Response to Public Hearing Docket #2022-P-W-0003; Fort DuPont Redevelopment and Preservation Corporation Subaqueous Lands Permit Application

Figure 4. Previous Design

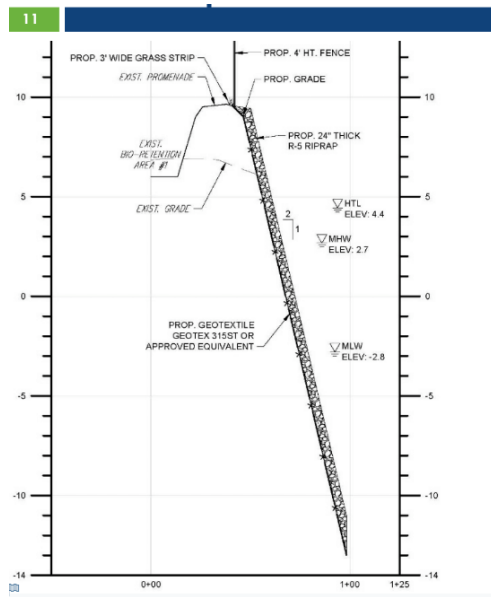
However, there was no inclusion of a method to hold the Geotextile material in place. Previous comments mentioned the use of a trench by which the Geotextile might be able to be anchored. Below are two illustrations.

On the left is the applicant's previous design shown as Slide 11 of the January 2021 Public Hearing Presentation. This design does not have the anchor toe along the base of the revetment. The applicant's plan was updated to reflect an anchor toe. However, there are still design flaws.

Figure 5. Delaware City Marina Design

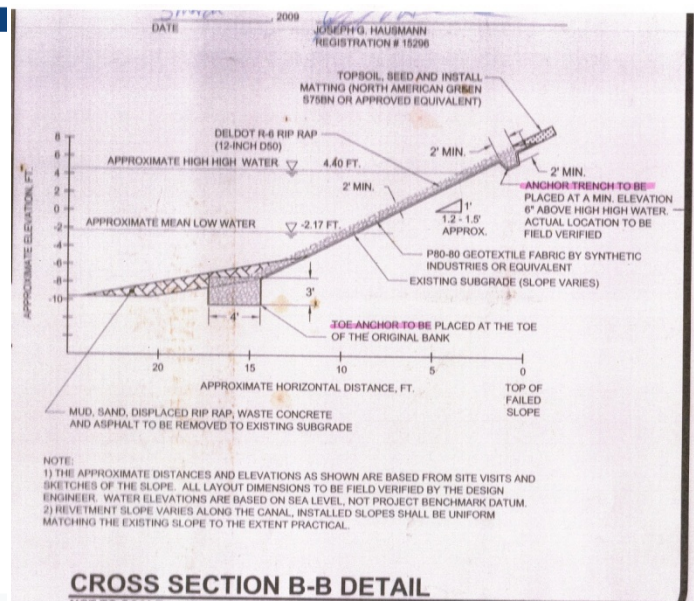
Figure 5 depicts the Duffield design used to create the revetment at Delaware City Marina. Photos of that completed design are shown in Figure 1. Figure 5 above shows a keyway along the top of the revetment dug into the slope. This keyway is in Figure 5 and appears on the right hand edge of the drawing and labeled "ANCHOR TRENCH TO BE....". This keyway design holds the filter cloth in place. This helps hold the filter cloth in place and helps the rip-rap maintain its shape.

Even the more robust design shown in Figure 5 has resulted in slope failure after installation. This is a critical element. If one of the design benefits is to protect the heavier, more trafficked infrastructure that is closer to the edge of the bank than that infrastructure on the west, then there must be a new, more robust design.
